ELLWOOD HOUSE

2262 BRAESIDE AVENUE TRANSPORTATION IMPACT ASSESSMENT FINAL REPORT

FEBRUARY 09, 2023

COMMENT AND RESPONSE LOG

Figure 2-2: Bicycle and Pedestrian Facilities

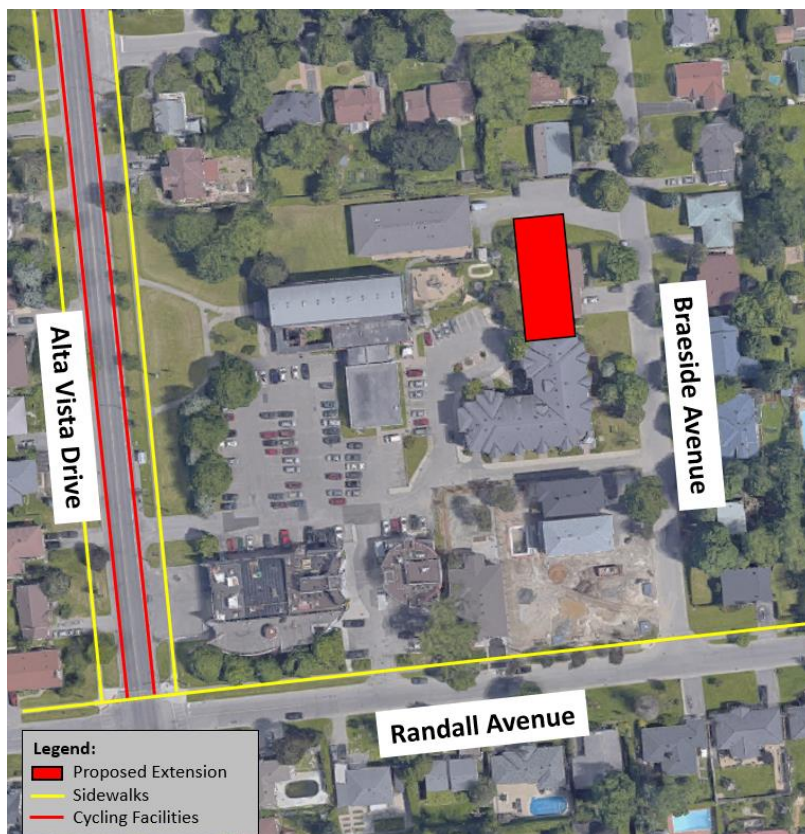
- 1 The legend of Figure 2-2 has an error: yellow lines are sidewalks, and red lines are cycling facilities
The figure has been updated in Section 2.3.1 of the TIA Final Report with the revised legend.

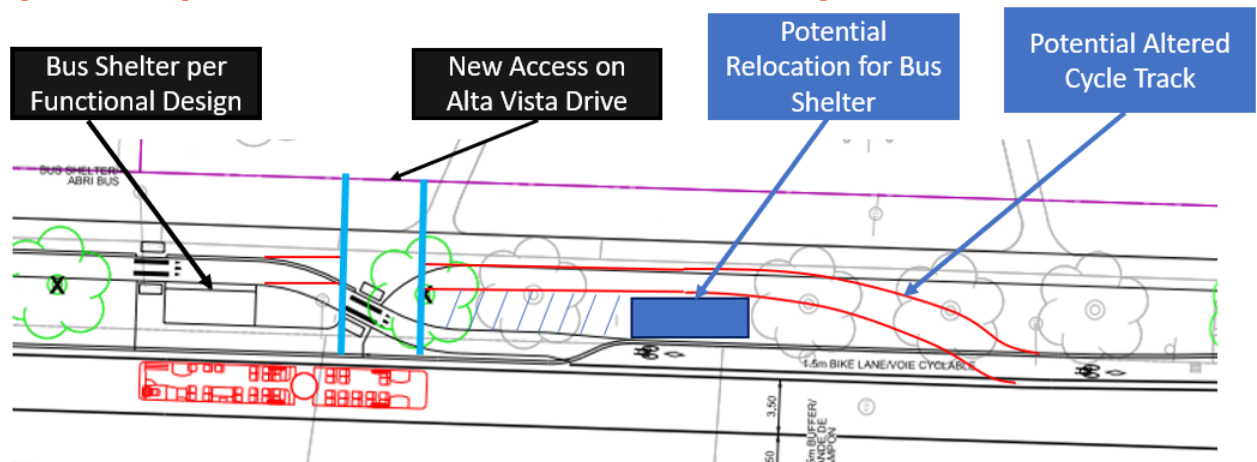
- 3 Note that the approved Alta Vista Drive Functional Design Study proposes relocating northbound Bus Stop ID: 7180 further north – to a location approximately 125m north of Randall Avenue. The development's proposed new access to Alta Vista Drive conflicts with this approved relocation of Bus Stop ID: 7180. Section 4.4.1 must address this conflict. Document the Appendix A response to this issue in Section 4.4.1 of the report, including details on where the proponent proposes to relocate Bus Stop ID: 7180. Consider the potential to remove the new Alta Vista Drive access from the plans.

The new Alta Vista Drive access is necessary to provide the parking required by the different campus uses and provide adequate circulation within the shared parking lot. The location of the bus shelter could be shifted south by an estimated 20-25 m with the bike lane bumping in earlier than currently proposed as shown in the below sketch. Suggestion for this consideration in consultation with OC Transpo and City of Ottawa Planning is proposed. This response was documented in Section 4.4.1 of the TIA Final Report.

DRAWING TITLE
SITE PLAN

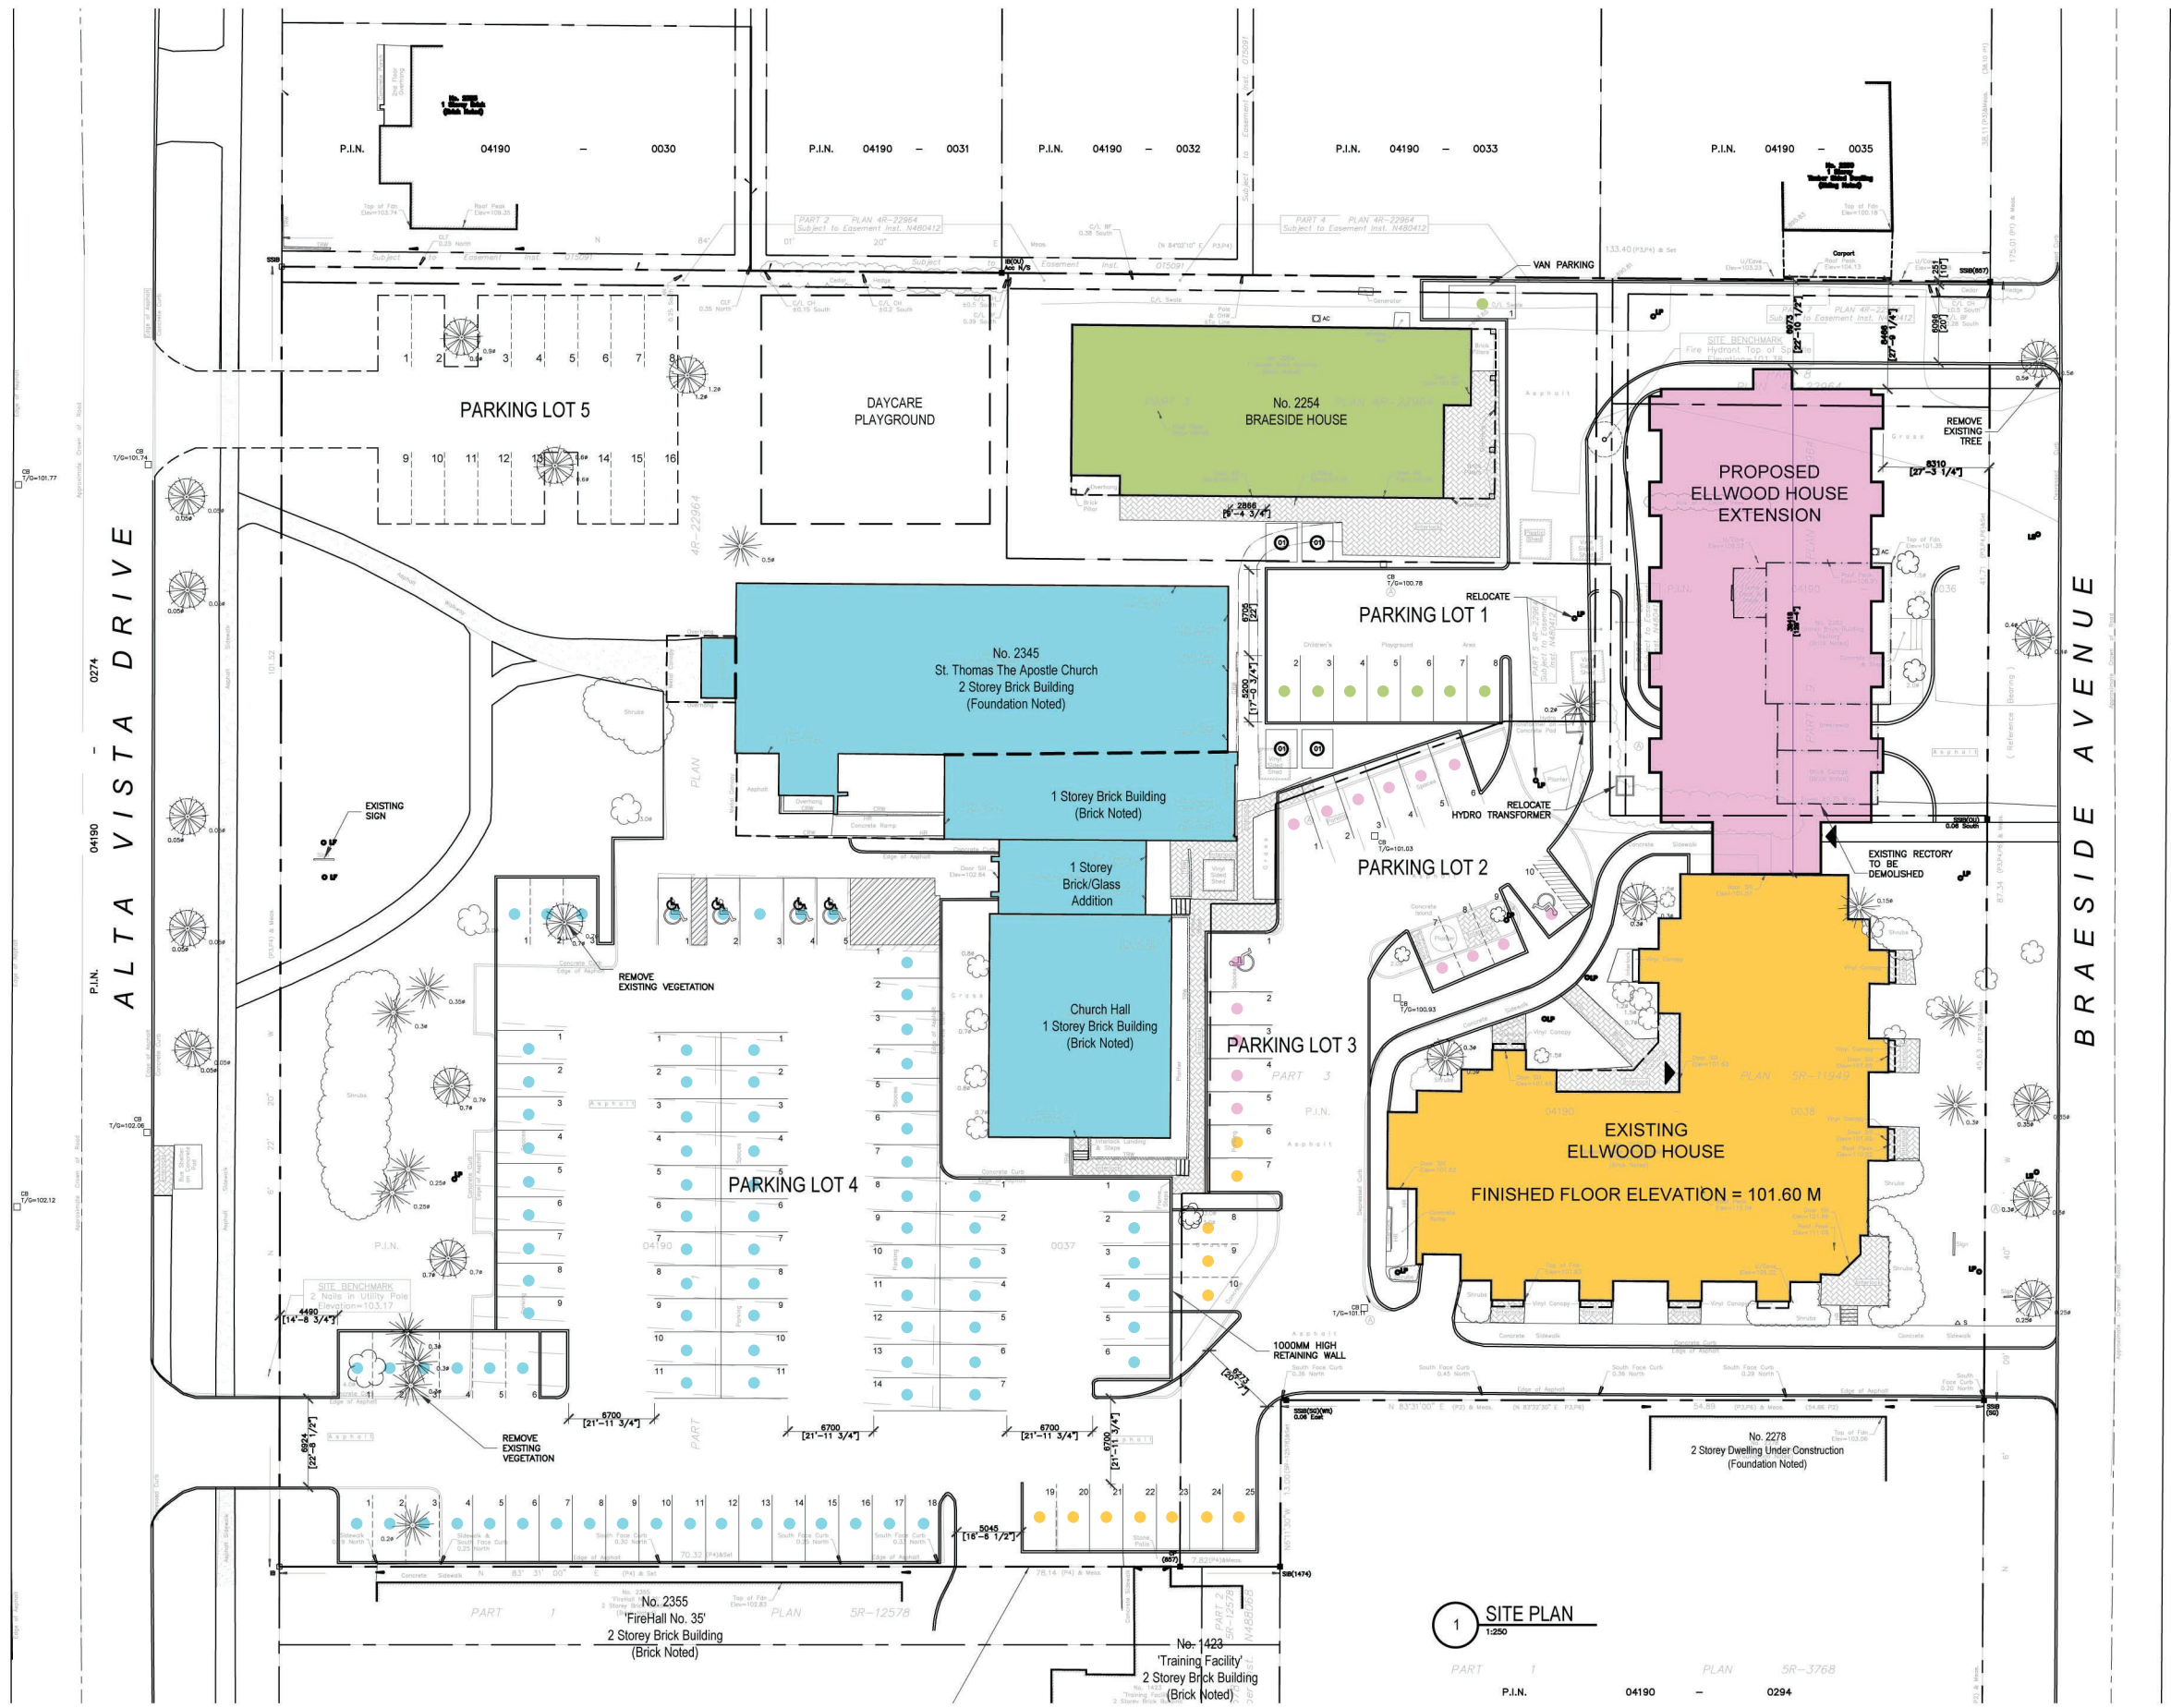
- 3 Confirm that the proposed site plan does not conflict with the approved Alta Vista Functional Design Study
The proposed site plan does conflict with the Alta Vista Functional Design Study. More specifically, the proposed driveway on Alta Vista Drive conflicts with the location of the relocated NB bus shelter. The location of the entrance has been developed in its current location so as to preserve and maximize public space (i.e. community gardens) and provide more direct access to accessible parking. Given the construction of the proposed development is expected before the Alta Vista Corridor Road Detailed Design, it is recommended that the final bus shelter location be identified during the Alta Vista Corridor Detailed Design in consultation with OC Transpo (e.g. south of the proposed driveway).

- 5 The realigned Braeside Avenue access is less than 3m away from the adjacent property line. This does not conform to section 25.1.p of the PABL and if accepted would require a bylaw exemption.
The bylaw includes an exemption where the offset can be minimized to 0.3 meters provided that the proposed access is located a safe distance from the access serving the adjacent property, adequate sightlines are provided and does not create a traffic hazard. The current plan shows a 2-meter offset. The safety review in Section 4.3.2.2 of the TIA Final Report indicates that there were no collisions on Braeside Avenue from 2015 to 2019 and given the geometric layout of the road (no bends or curves) a bylaw exemption should be feasible and will be pursued as required.

- 6 Please provide slope of accesses. Note that as per section 25.1.u of the Private Approach By-Law, the slopes should not exceed 2% for a distance of 9 metres from the street line.

Additional details will be provided in updated Site Plan.
